**PLANNED UNIT DEVELOPMENT
& SUBDIVISION STAFF REPORT****Date: January 6, 2011****DEVELOPMENT NAME**

Tuthill Gates Subdivision, Resubdivision of

APPLICATION NUMBER 21 & 22 DATE January 6, 2011

SITE PLAN

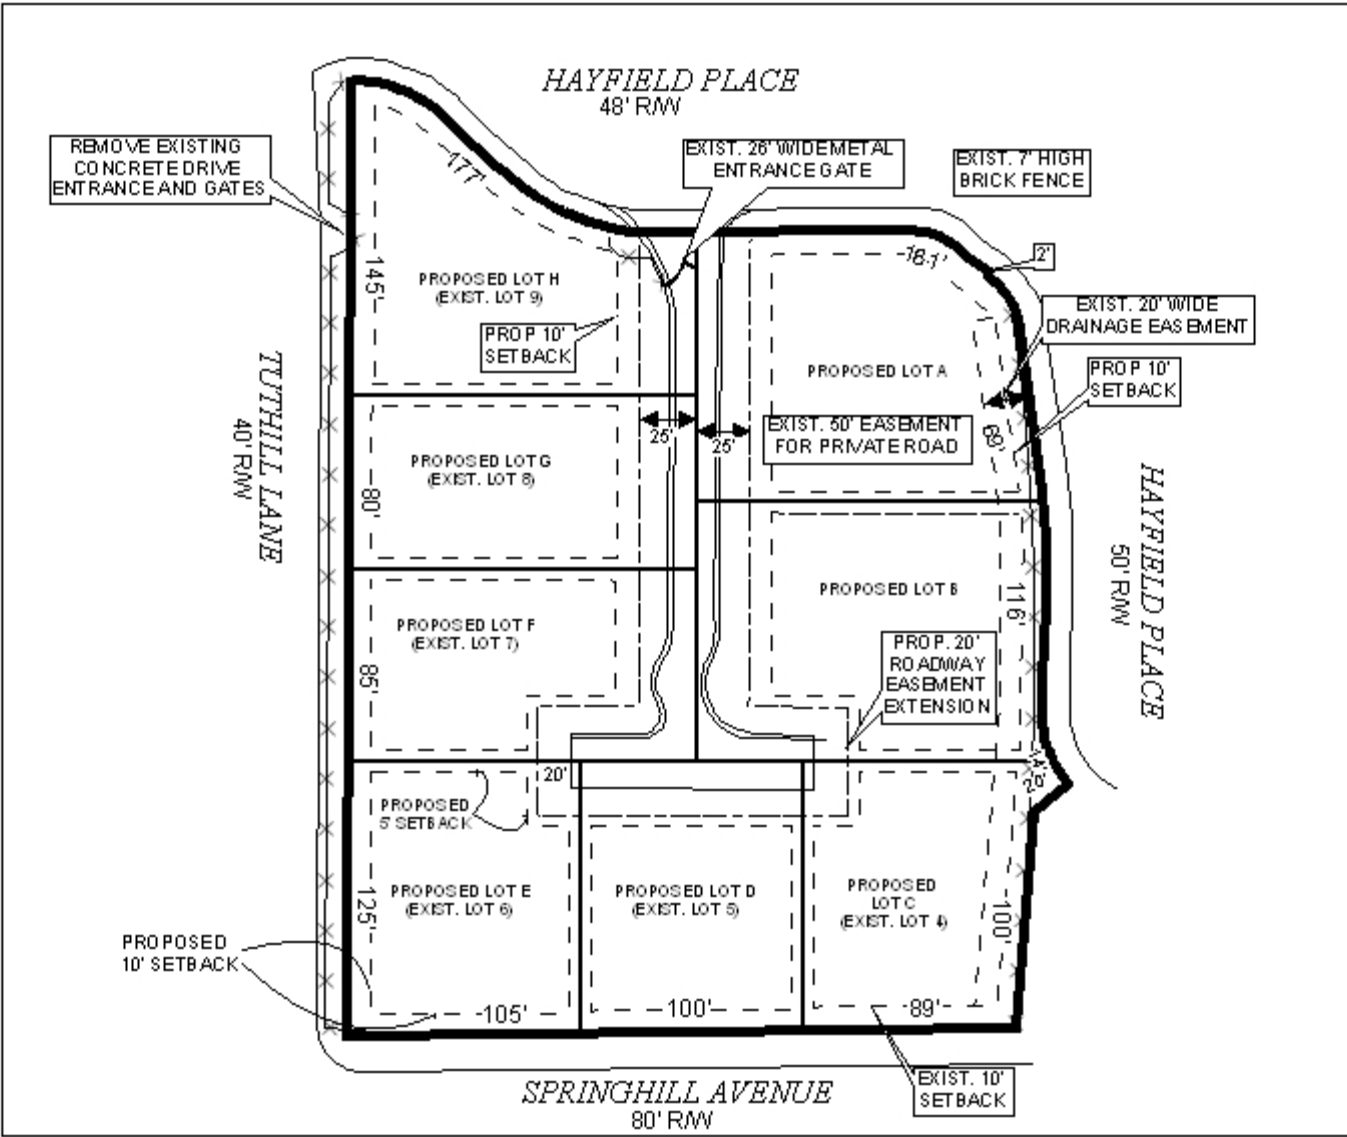
Setbacks shall not include drainage easements, structures are prohibited within drainage easements. Reduction in size of any drainage easements are not allowed. Any new wall or fence proposed within a drainage easement will require Engineering, ROW and Zoning approvals. Must comply with all storm water and flood control ordinances. Any increase in impervious area in excess of 4,000 square feet will require detention. Any work performed in the right of way will require a right of way permit. Drainage from any dumpster pads cannot discharge to storm sewer; must have connection to sanitary sewer.

Preservation status is to be given to the 48" Live Oak Tree located on private easement in front of Lot B. Any work on or under this tree is to be permitted and coordinated with Urban Forestry; removal to be permitted only in the case of disease or impending danger.

The applicant specifically requests a 10-foot setback where the lots abut adjacent streets, and requests 5-foot side yard setbacks within the development. A building setback ranging from 5 to 10 feet is proposed along the proposed 50-foot wide private road easement. The applicant additionally requests that the maximum site coverage be increased from 35% (allowed by right in R-1) to 45%.

Regarding the reduced front yard setbacks, typically a 25-foot front yard setback is required along all street frontages, however a 10-foot setback is being requested. The previously approved subdivision for the site required a 20-foot setback along Spring Hill Avenue, and a 25-foot setback from Tuthill Lane and Hayfield Place. Other homes along Hayfield Place appear to meet the minimum 25-foot setback, however, none of the lots within the development will have direct access to Hayfield Place, relying instead on a private street internal to the development: the abutting public streets will be the “backyards” of the homes built as part of the proposed development. As that portion of the site abutting Hayfield Place to the East is constrained by a 20-foot drainage easement, and as Spring Hill Avenue is a proposed major street, and Tuthill Lane a minor street with a substandard right-of-way, it is recommended that all setbacks from adjacent public streets be a minimum of 20-feet, requiring a waiver of Section V.D.9. of the Subdivision Regulations. Furthermore, a 20-foot setback would be more in keeping with the existing development on Hayfield Place.

The side yard setbacks internal to the development are proposed to be 5 feet, instead of the typically required minimum of 8 feet. This request only appears to create a concern as it relates to an existing drainage easement between Lots C and D: in this case, the minimum side yard setback for Lot D adjacent to the easement should match the easement line (10 feet), so that there is no confusion regarding where a structure can be built.

The proposed building setback from the private street easement ranges from 5 feet at the hammerhead turn-around, to 10 feet along the main portion of the private street. As the lots actually go to the centerline of the private street easement, the proposed minimum building setbacks appear to be adequate to ensure the function of the private street and necessary utilities.

Regarding the increased building site coverage to 45%, the existing storm water system on site must be confirmed to be able to handle additional runoff that may be generated by increased building site coverage. While the proposed lots will exceed minimum size standards, it is not uncommon for the developers to request increased site coverage as part of a PUD application. The smallest proposed lot will be 12,500 square feet, of which the applicant states that its net buildable area will be 7,000 square feet (less setbacks and easements): the maximum ground floor building site coverage for this lot would go from 4,375 square feet (35%) to 5,625 square feet. Since, in the case of this development, the applicant proposes that the private road easement is part of the lot size, it would appear that an increase in building site coverage to 45% may not be necessary.

Regarding road access for the lots, all lots should be denied direct access to Tuthill Lane and Spring Hill Avenue, and only allowed access to Hayfield Place via the private road.

It appears that a portion of the existing masonry wall for the site is within the right-of-way for Hayfield Place and Tuthill Lane. Also, it appears that there is an existing fence within the Tuthill Lane right-of-way. Any walls or fences within the public right-of-way must be removed, or a non-utility right-of-way use agreement must be completed by the applicant and approved by the City of Mobile. No new walls or fences are depicted, however, any new walls or fences must meet all required setbacks, be properly permitted, and must comply with any limitations as it relates to placement within drainage easements: new walls or fences above 3 feet in height cannot be built within any required setbacks from public streets.

- 4) Depiction of a 20-foot setback where each lot abuts a public street;
- 5) Depiction of a 10-foot side yard setback for Lot D, where there is an existing drainage easement on the North side of the lot;

- 6) Depiction of all other internal side yard (5 feet) and private street minimum building setbacks (5 to 10 feet) as proposed;
- 7) Placement of a note on the final plat stating that all lots are denied direct access to Spring Hill Avenue, Tuthill Lane and Hayfield Place, and that access shall only be to Hayfield Place via the proposed private street easement;

- 1) Placement of a note on the site plan stating that the maximum building site coverage is limited to 35%;
- 2) Any new walls or fences to comply with all setbacks requirements, as well as any other municipal codes and ordinances;

- 6) Depiction of a 20-foot setback where each lot abuts a public street;
- 7) Depiction of a 10-foot side yard setback for Lot D, where there is an existing drainage easement on the North side of the lot;

- 8) Depiction of all other internal side yard (5 feet) and private street minimum building setbacks (5 to 10 feet) as proposed;
- 9) Placement of a note on the site plan stating that all lots are denied direct access to Spring Hill Avenue, Tuthill Lane and Hayfield Place, and that access shall only be to Hayfield Place via the proposed private street easement;

- 13) Provision of a revised PUD site plan prior to the signing of the final plat; and
- 14) Full compliance with all other municipal codes and ordinances.
